Determination 2011/076

Regarding the code-compliance of an infinity edge and a weir to a swimming pool at 15 Hanene Street, St Heliers, Auckland

Figure 1 Cross section through north end of pool

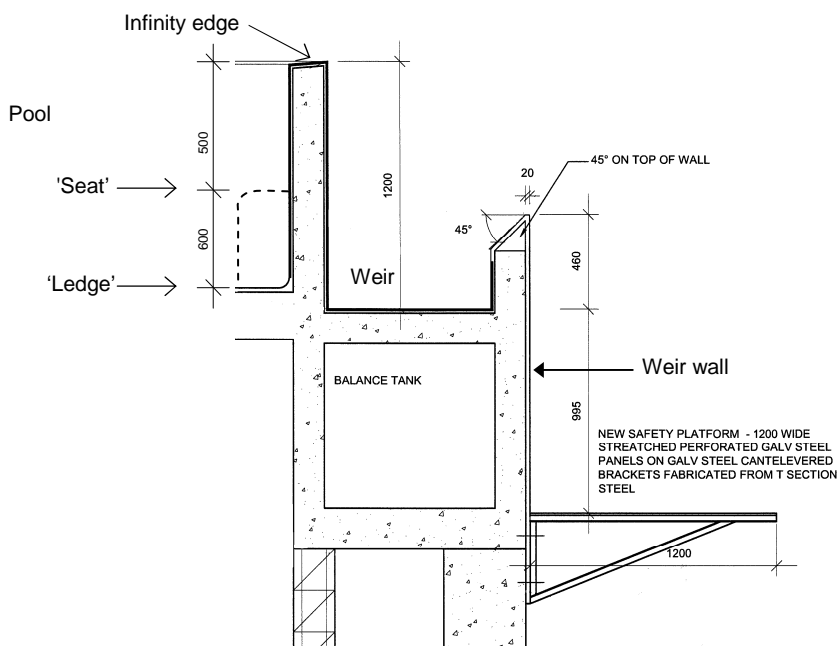
- 2.4.1 The northern end of the pool incorporates an infinity edge. The pool wall at this point is approximately 200mm wide, with a glass tiled top sloping at a 10° angle in towards the pool. The water from the pool runs over this edge into a tiled weir 1200mm below (refer figure 1).

- 5.2.7 I consider the infinity edge is readily accessible by people wishing to climb into it, walk along, sit on, dive from, or reach while on a floatation device. For these reasons, as I consider that it is likely that someone could fall from the infinity edge, and that, because the distance from the top of the pool edge to the weir below is greater than 1m, the infinity edge does not comply with Clause F4.3.1 of the Building Code.

- 5.4.4 However, the fall height is still over the 1m allowed by Clause F4.3.1, and as discussed in section 5.5.4, I consider the 260mm difference in fall height to be material, especially when falling onto a hard surface. I consider that with respect to the weir the revised design, with the inclusion of the ‘safety platform’ at 1260mm below the outer edge of the weir, does not comply with Clause F4.

7.1 In accordance with section 188 of the Building Act 2004, I hereby determine that the revised design for the infinity edge and weir to the pool does not comply with Clause F4 of the Building Code with respect to Clause F4 Safety from falling.

Figure 2 Site plan of north end of pool

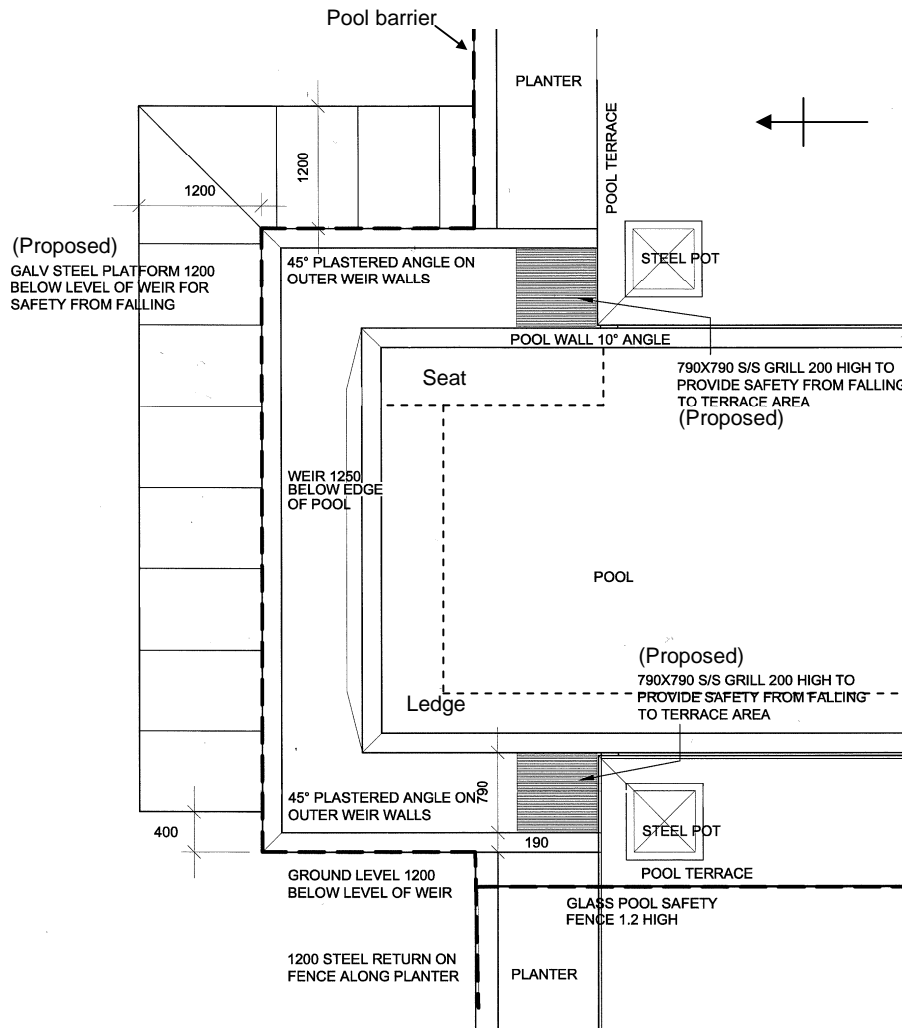
- 5.3.1 The revised design contains two components to reduce the fall height from the terrace on either side of the pool and restrict access to the weir from those points. The first is two mesh trays that would be installed on the floor of the weir adjacent to the terrace on the east and west side. The second is the installation of a large fixed pots on the terrace, 250mm back from the pool coping, at point where the terrace meets the weir at the northeast and northwest points.

- 5.3.2 The mesh trays would reduce the fall height at that point to 1m. However, I note that the trays are only 800mm wide and I consider that insufficient in terms of a safe landing platform. I do not consider the provision of the trays provide a code-compliant solution to avoid the likelihood of injury arising from a fall from the terrace onto the weir.

- 5.3.4 The pots may be sufficiently large to effectively block access to the weirs but details of the pots will need to be provided to the authority in order to confirm this.
